TEXAS COMMISSION ON ENVIRONMENTAL QUALITY

April 25, 2022

Re: Comments on the United States Environmental Protection Agency's (EPA's) Air Plan Disapproval; Arkansas, Louisiana, Oklahoma, and Texas; Interstate Transport of Air Pollution for the 2015 Eight-Hour Ozone National Ambient Air Quality Standards (NAAQS), Docket ID No. EPA-R06-OAR-2021-0801

**COMMENTS BY THE TEXAS COMMISSION ON ENVIRONMENTAL QUALITY
REGARDING AIR PLAN DISAPPROVAL; ARKANSAS, LOUISIANA, OKLAHOMA, AND
TEXAS; INTERSTATE TRANSPORT OF AIR POLLUTION FOR THE 2015 EIGHT-HOUR
OZONE NATIONAL AMBIENT AIR QUALITY STANDARDS**

Figure 1. Difference in Design Value Predicted in 2023 versus Observed in 2020. Predictions are from the EPA 2011 modeling (upper left), TCEQ 2012 modeling (upper right), and EPA 2016 modeling (lower)

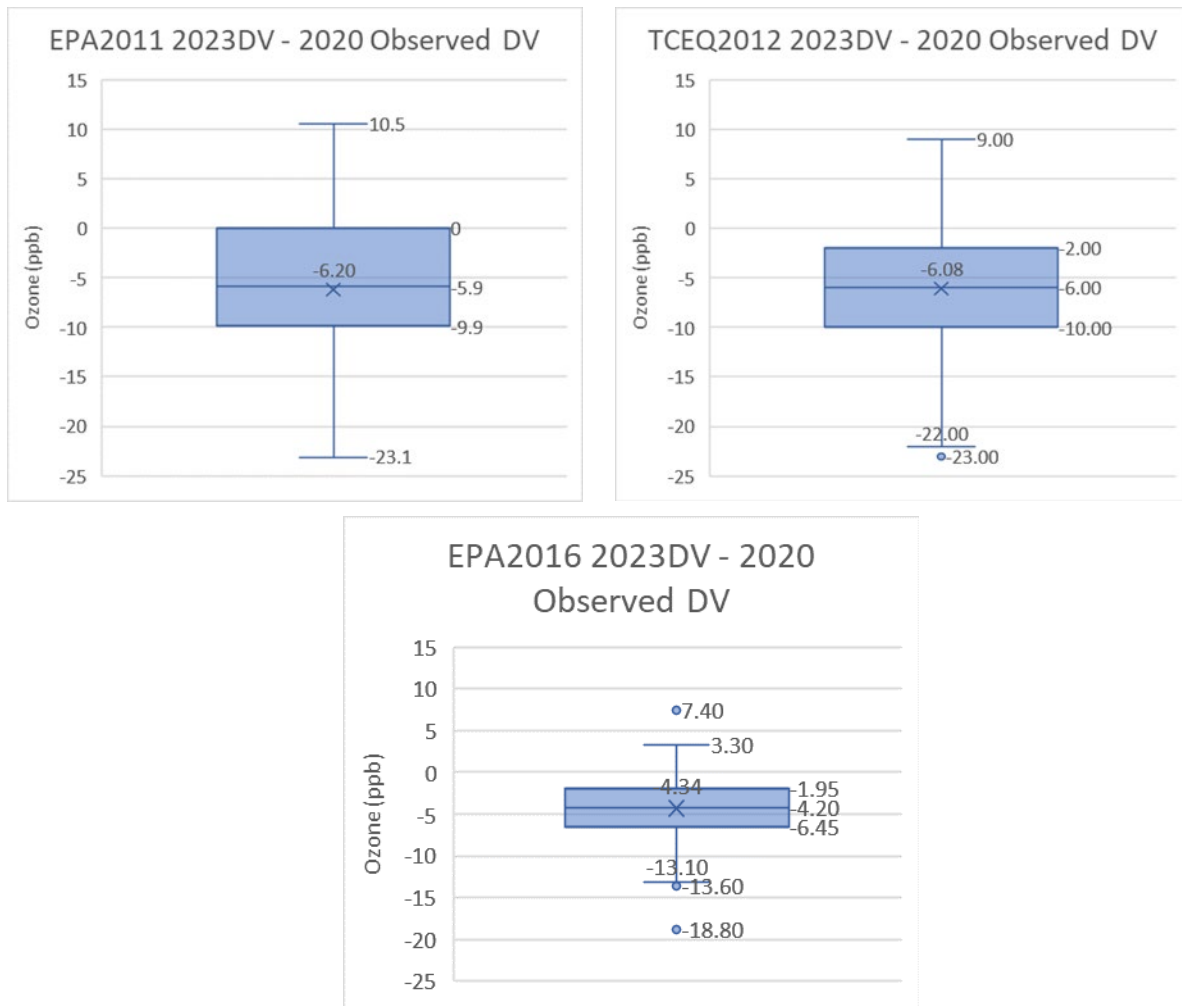
Analysis of the EPA and TCEQ modeling also shows greater difference between the predicted 2023 design values and the observed 2020 design values as the prediction time lengthens. Figure 2, Difference in Design Value Predicted in 2023 versus Observed in 2020. Predictions are from the EPA 2011 modeling (upper left), TCEQ 2012 modeling (upper right), and EPA 2016 modeling (lower) shows that the mean difference across common monitors decreases from -6.20 ppb for a 12-year prediction time, to -6.08 for an 11-year prediction, to -4.34 for a seven-year prediction time. The shaded interquartile range of the distribution also tightens with decreasing prediction time, indicating uniformly better prediction. Note that the TCEQ 2012 modeling shows a similar design value difference to the EPA 2011 modeling indicating similar performance. The difference in design values is largely explained by the shorter prediction time, as seen in Figure 2, Difference in Design Value Predicted in 2023 versus Observed in 2020 versus Length of Prediction, where the TCEQ 2012 modeling

Figure 2. Difference in Design Value Predicted in 2023 versus Observed in 2020 versus Length of Prediction

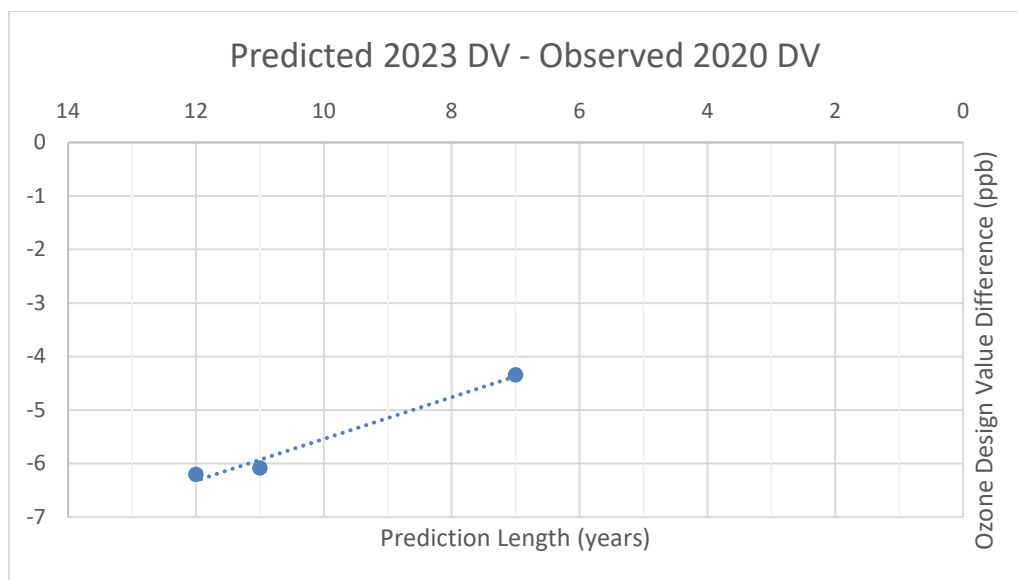
is shown as the eleven-year prediction length roughly on the linear trend of the three models.
